Hamilton County MSD Monitor

Cost Certainty Analysis of SI Alternative

August 28, 2012

From ODOT's "Procedure for Budget Estimating (July 11)"

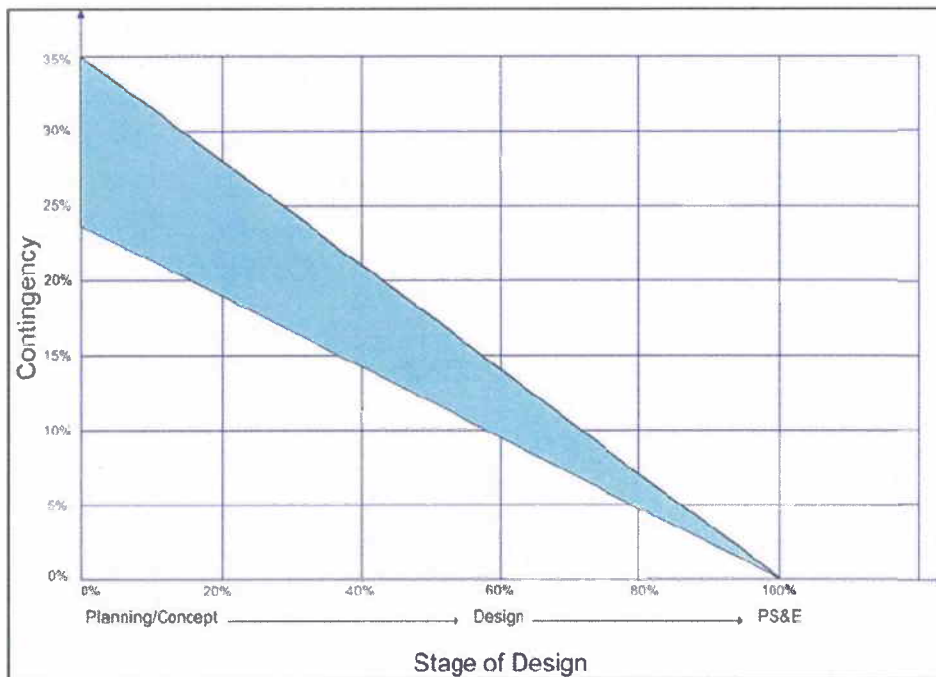
9. Design contingencies factors are outlined in the SI Alternative report. For comparative purposes, the values reported generally comply with ODOT's ranges, but typically fall within the lower end of the range. The project stage multipliers appear low when compared with ODOT's estimating procedure, see Attachment 2. It appears the project multipliers used for project stages "Preliminary Design" and "30% Design" are at least 5% low ⁷.
